- **TMC261-PA**
- **TMC261-PA-T**
- **TMC261-PA-X**

## Product Change Notification

**PCN-2019-08-04**

**August 29, 2019**

Figure 1: TMC261(A) block diagram

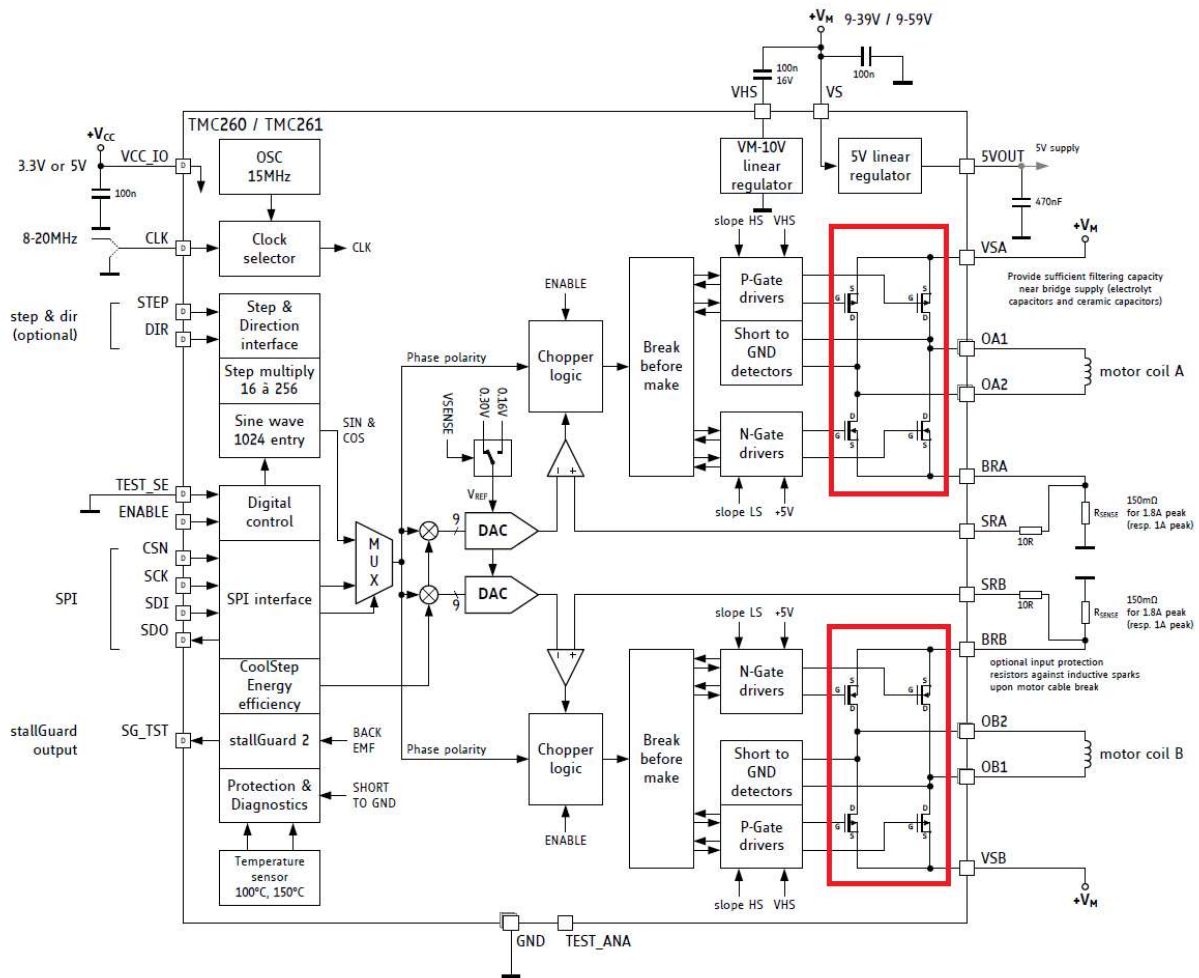
Due to product maintenance and to assure longevity of the TMC261 we qualified a new wafer fab for TMC261 motor driver MOSFETs full-bridges. Hardware changes:

- Motor driver N-channel MOSFET (4pcs. in total)
- Motor driver P-channel MOSFET (4pcs. in total)
- Revision field of IC label will change to "A". (TMC261 to TMC261A)
- New motor driver MOSFETs will improve power losses due to lower Rdson

You can find the relevant MOSFETs (red marked) in the block diagram in figure 1. Due to the multi-chip structure of the TMC261 only motor driver MOSFET dies are affected to the changes. Complete digital and analog part of the core die as well as lead frame and IC structure stays unchanged.
